# UNITED STATES PATENT AND TRADEMARK OFFICE

APPLICATION NO.	FILING DATE	FIRST NAMED INVENTOR	ATTORNEY DOCKET NO.	CONFIRMATION NO.
09/877,217	06/11/2001	Ikuya Tsurukawa	206470US-2	9559

**Office Action Summary**

## **DETAILED ACTION**

Yamaguchi figure 1.

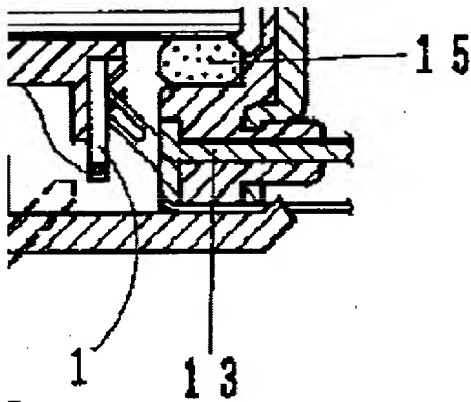
11. Applicant's arguments filed 3/7/2006 have been fully considered but they are not persuasive. Applicant's arguments regarding Yamaguchi are not persuasive because all the limitation are show by Yamaguchi as cited above. Particularly, the brush 11 with terminals 13 extending from the base 12 is shown in figure 2. The prior art of record

repeatedly shows the amended limitations: see CN 87 2 15879U as one of many examples (original IDS filed 10/9/03).
